MOD_20_21 and other undo scenarios

**Changes to Appendix O for Instruction Profiling and Bid Offer
Acceptance Quantity Outcomes in a Subset of Undo Scenarios**

Katia Compagnoni
02nd December 2021

Scenario 2 – Happening in systems

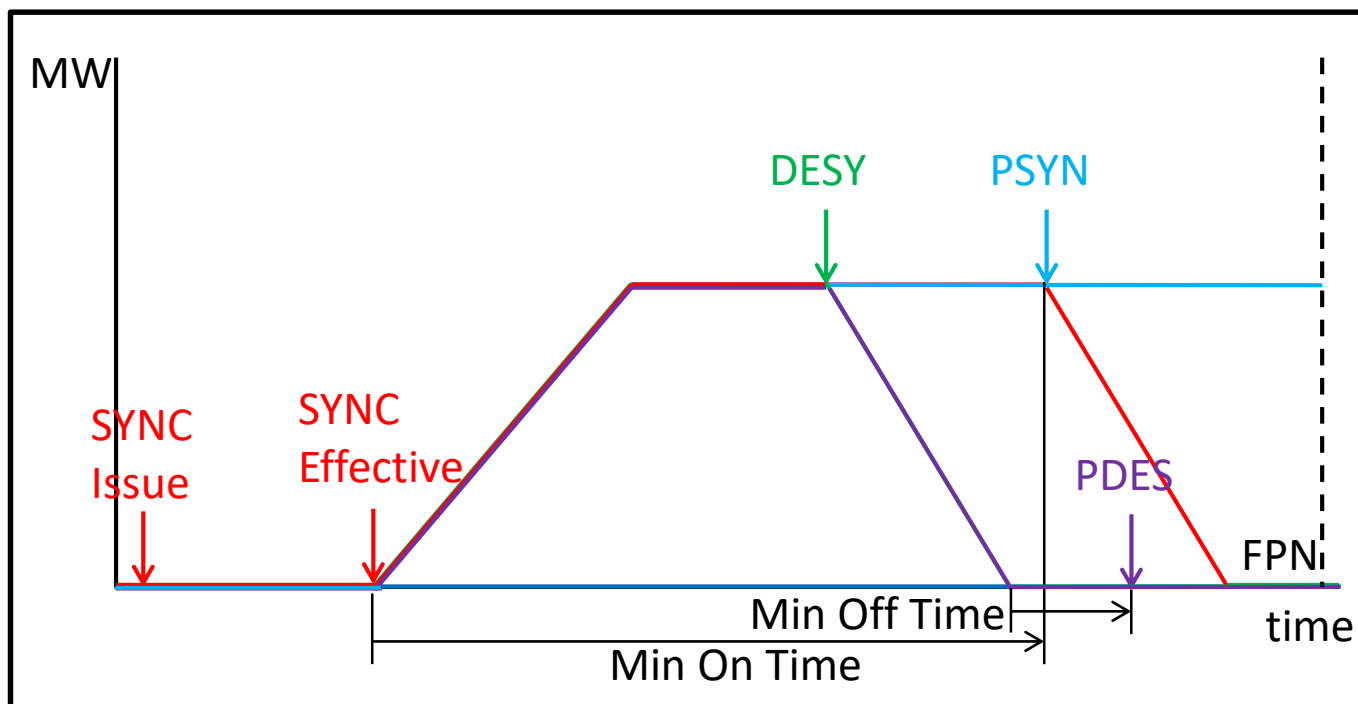
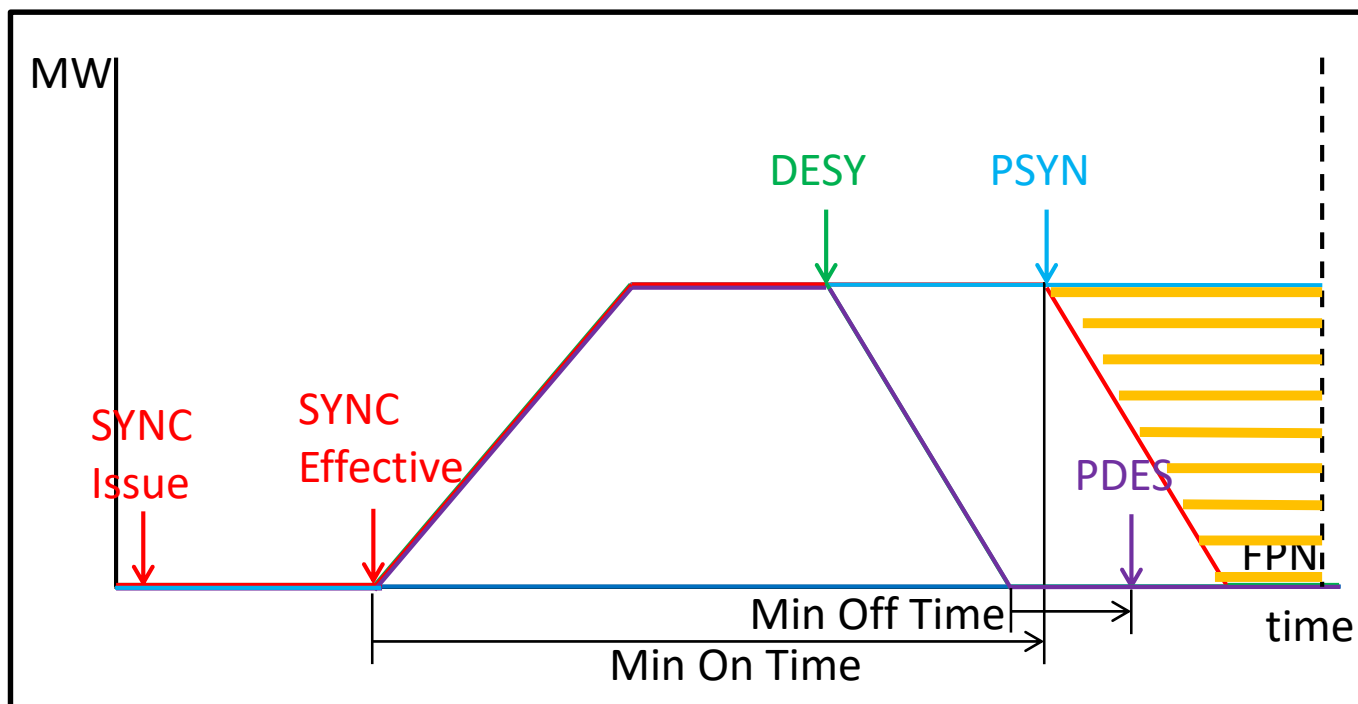
SYNC and DESY after MSG before Min On Time

Profile will return to 'normal' after PISP (pseudo instruction at the Imbalance Settlement Period boundary) which will close off Pseudo Instructions

- Additional paragraph in the PSYN definition **Appendix O.16 Table 3**
 - If a subsequent DESY Dispatch Instruction has an Instruction Effective Time which is between the Instruction Effective Time of a prior SYNC Dispatch Instruction and the Instruction Effective Time of the corresponding PSYN Pseudo Dispatch Instruction that would nominally be created, but after the time when the Physical Notification Instruction Profile for the SYNC Dispatch Instruction reaches the Registered Minimum Stable Generation, then the PSYN Pseudo Dispatch Instruction that would nominally be created for the corresponding SYNC Dispatch Instruction shall be created.
